Design Review Subcommittee (DRSC)

Meeting Date: January 23, 2019

SUBJECT: **Pre-Application Review 18-234, In-N-Out**, a request to demolish the existing two-story bank building and build a new drive-through restaurant with outdoor dining area. The project is located within the West Pico Corridor Specific Plan (WPCSP) in the Community Commercial area.

Recommendations to Improve Architectural Quality

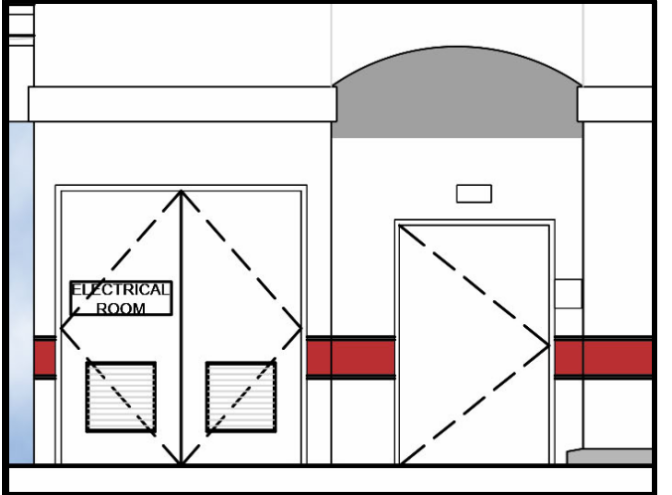
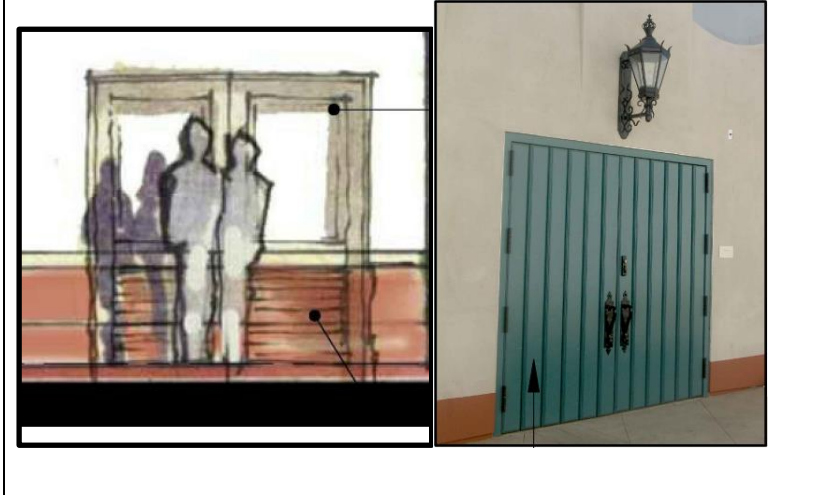
Recommendation no. from Staff Report	Proposed	Recommendation
<p>6. The roof should be predominantly single-barrel red tile, with parapet walls used sparingly to shield any rooftop mechanical equipment. The design utilizes a disproportionate amount of parapet wall with cornice in relation to the minimal amount of red tile roof only found on tower elements.</p>		
<p>7. Replace the cornice detail with exposed rater tails in areas of the roof line where red tile is used.</p>

Recommendations to Improve Architectural Quality

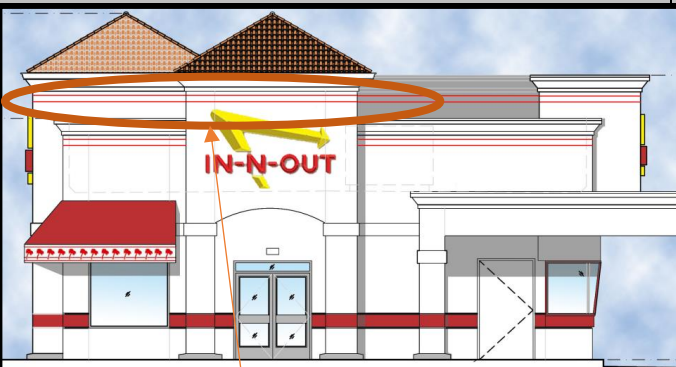
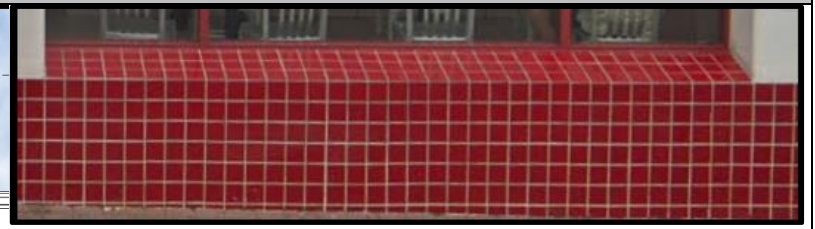
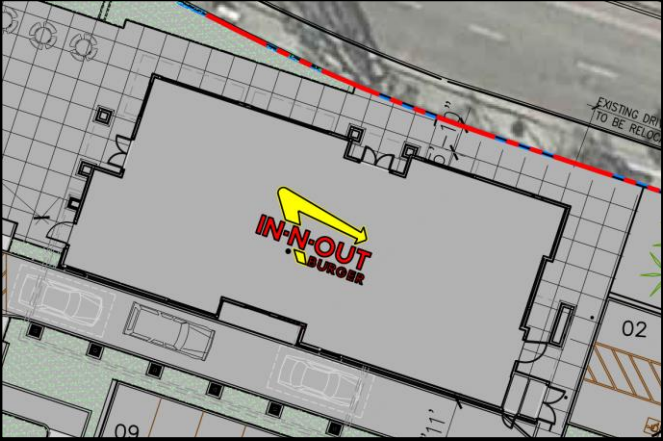
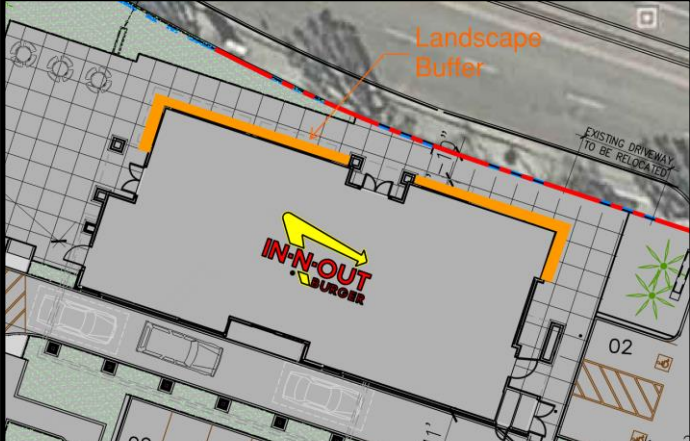
Recommendation no. from Staff Report	Proposed	Recommendation
<p>8. The drive-through canopy should be consistent, and utilize the same architectural elements for all openings throughout its design. Ensure proportionality is maintained between the size of the columns and the visual weight of the roof.</p>		
<p>9. Remove the banding located around the building and drive-through canopy.</p>	<p>—</p>

Recommendations to Improve Architectural Quality

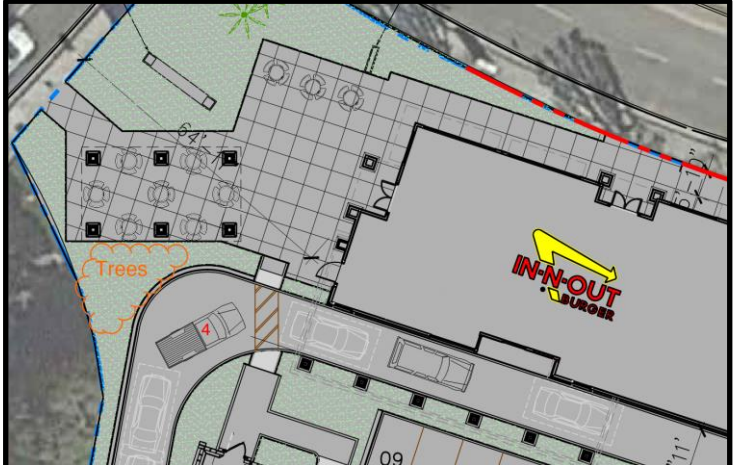
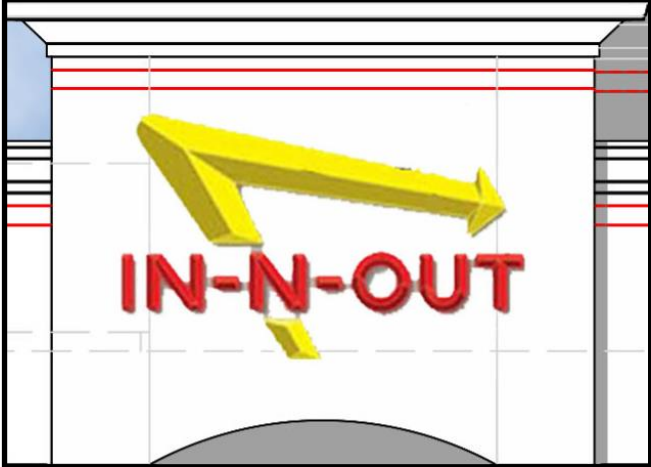
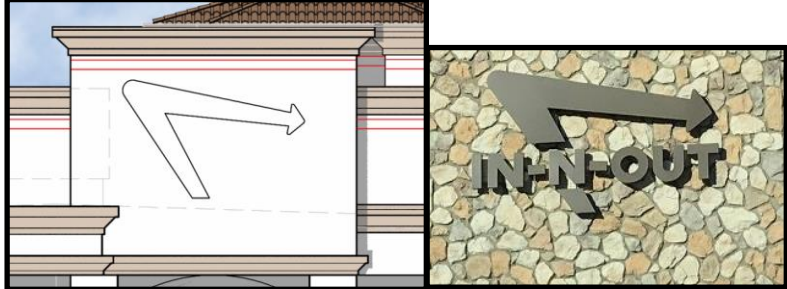
Recommendation no. from Staff Report	Proposed	Recommendation
<p>5. Ensure the trash enclosure is of SCR design.</p>	<p>No elevations proposed.</p>	 <p>The top image is an architectural elevation drawing of a trash enclosure. It features a pergola-style roof with dark wooden beams and a central window with vertical metal bars. The walls are light-colored with a darker base. Callouts '4' and '12' are present, along with a '1ST F.F. +0'' marker. The bottom image is a photograph of the existing trash enclosure, which is a dark-colored metal structure with a white pillar and a pergola roof, situated outdoors near a white wall and trees.</p>
<p>16. Use a landscape buffer to limit direct access to the white stucco building from patrons/general public who may scuff/dirty the building.</p>	 <p>The diagram shows a site plan with a grey building footprint labeled 'IN-N-OUT BURGER'. A red dashed line indicates the 'EXISTING DRIVEWAY TO BE RELOCATED'. The building is adjacent to a parking area with spaces labeled '02' and '09'.</p>	 <p>This diagram is similar to the previous one but includes an orange shaded area around the building labeled 'Landscape Buffer'. The 'EXISTING DRIVEWAY TO BE RELOCATED' is also indicated.</p>

Recommendations to Improve Architectural Quality

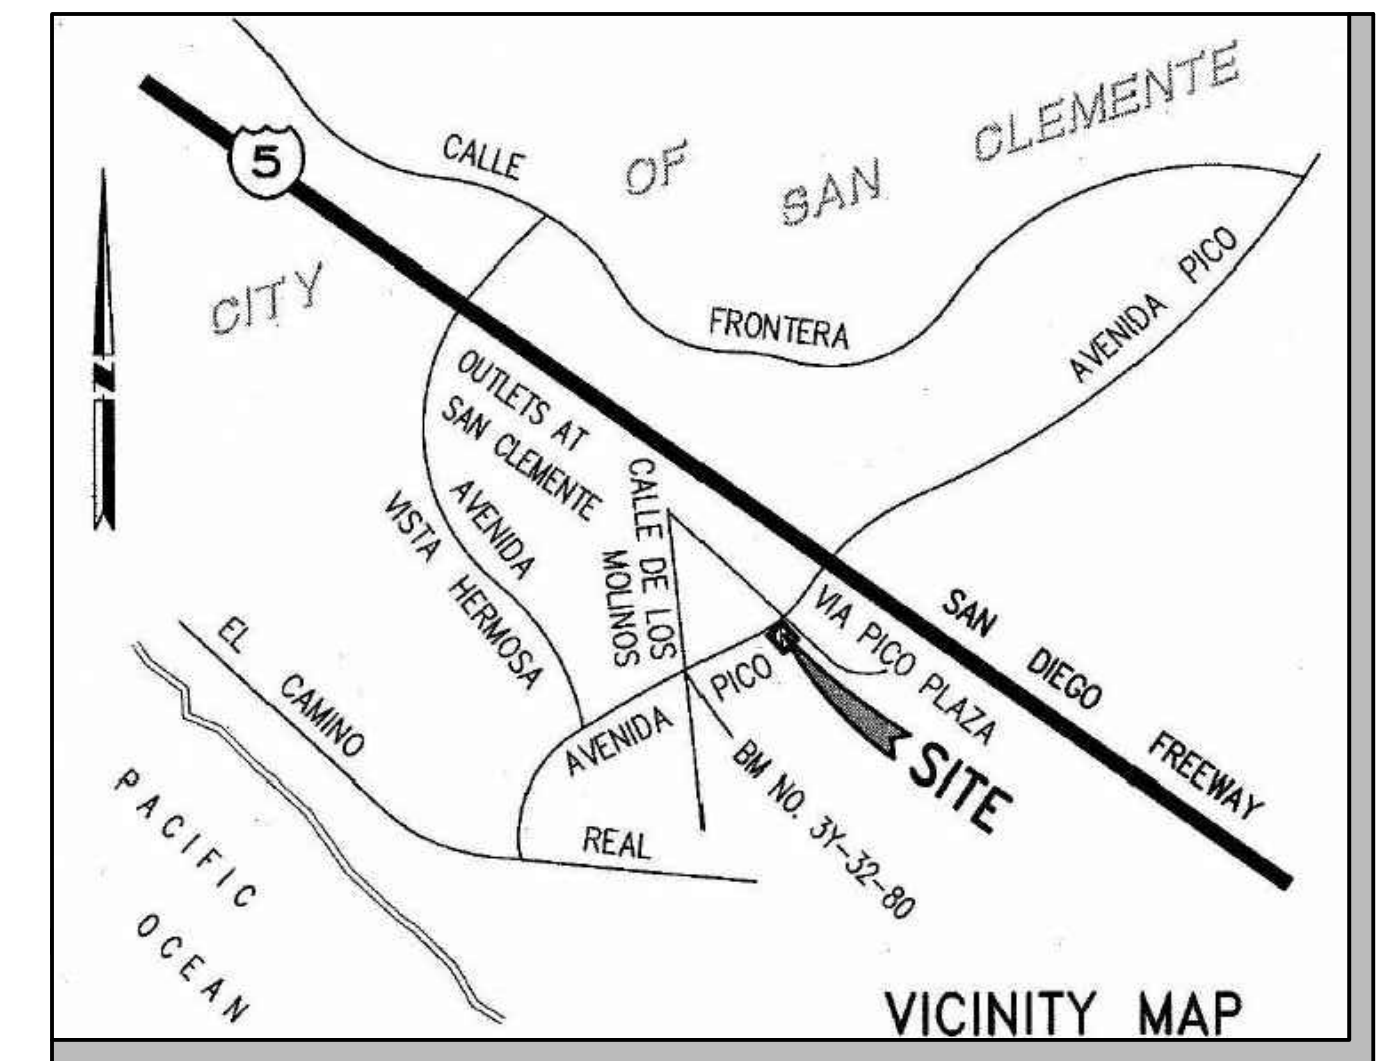
Recommendation no. from Staff Report	Proposed	Recommendation
<p>18. Place additional trees/landscaping behind the outdoor dining area to further shield the drive-through lane from Avenida Pico.</p>	<p>None depicted in this location.</p>	
<p>20. All signs should be consistent with SCR design, and be made of high quality materials, such as wood, metal, glass, etc. Plastic/acrylic signs are not permitted. On the first pre-application submittal, the architectural elevations depicted a recessed arrow on one of the building facades, which is more inline with SCR.</p>

1 SOUTH ELEVATION
SCALE: 1/4"=1'-0"

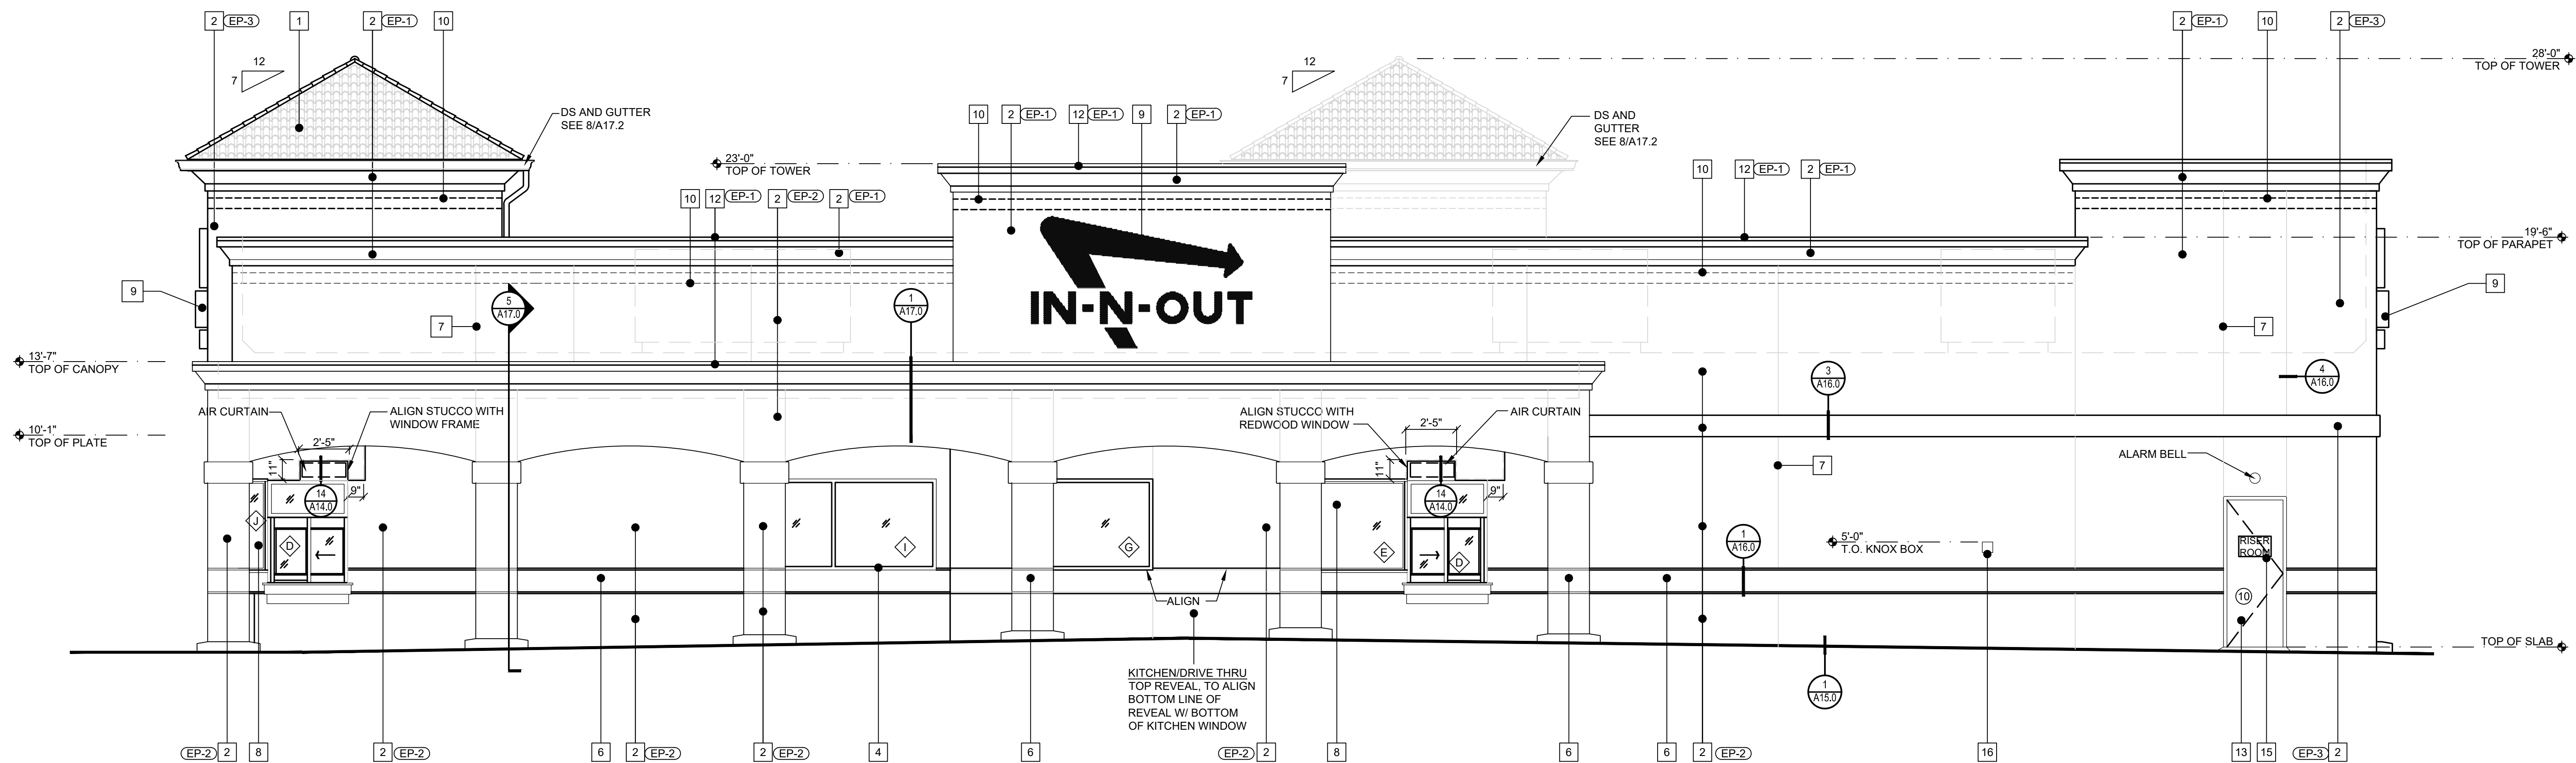
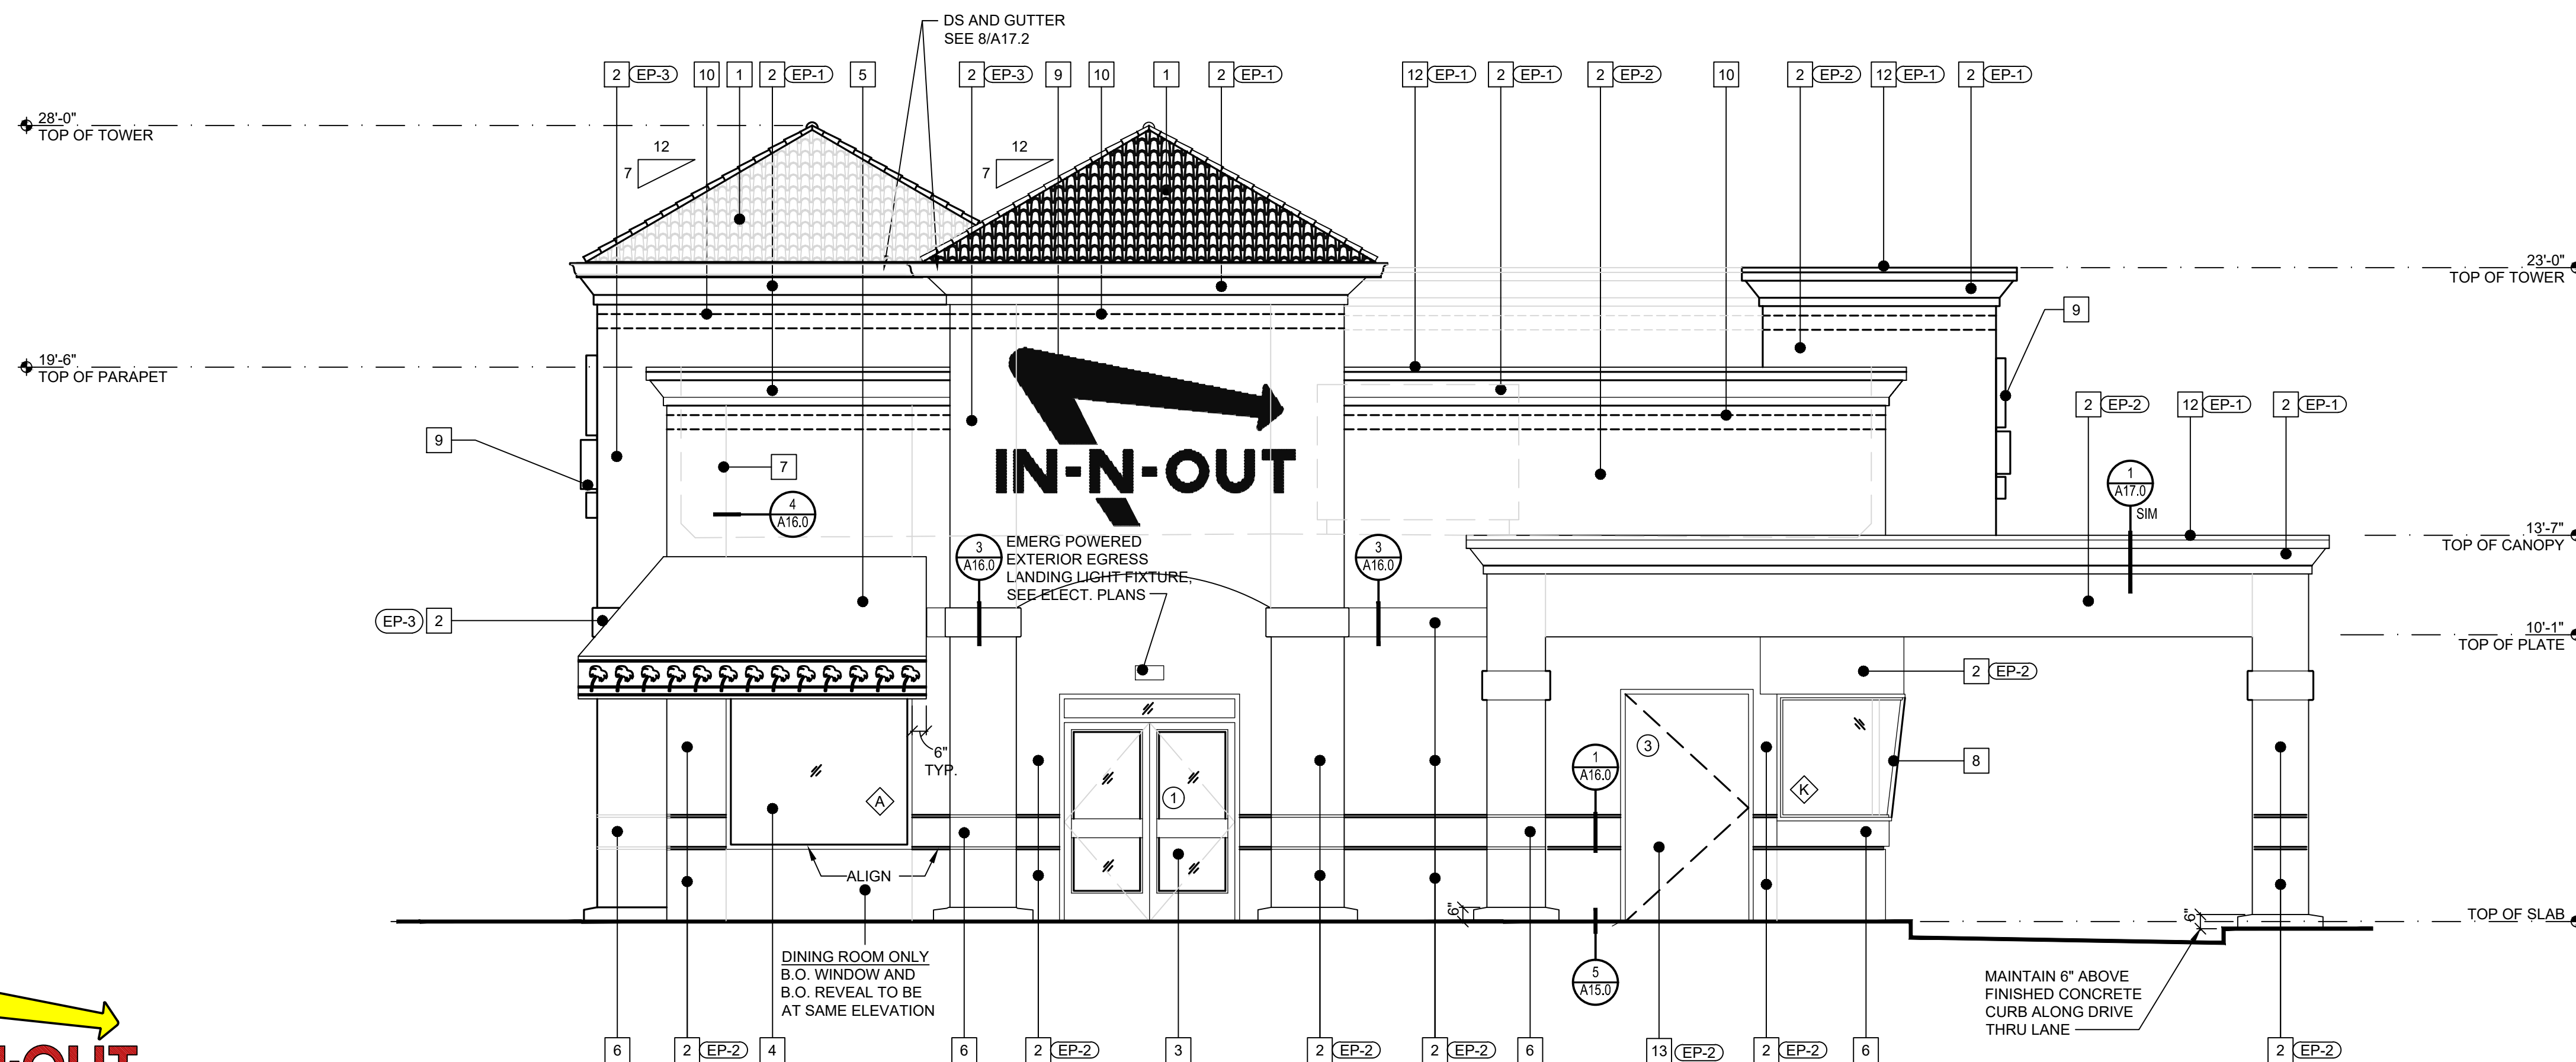
10. Improve the south-facing façade as it is visible from the public right-of-way. Consider using a more SCR style door design for the employee door, and ensure the design of the electrical doors blend into the design of the building. Appurtenances on this façade should be painted to match the building color or shielded by design elements.
11. The structure's windows and doors should be a color and material that supports SCR style, such as wood or metal, painted an earth-tone color. Windows should have lites and mullions, as opposed to large single-plate windows.
12. Remove the red L.E.D. strip from the top of the building.
13. Modify the red stripe to be consistent with SCR design, such as Spanish tile.
14. Utilize an awning color consistent with SCR design, such as an earth tone red.
15. Ensure the trash enclosure is of SCR design.
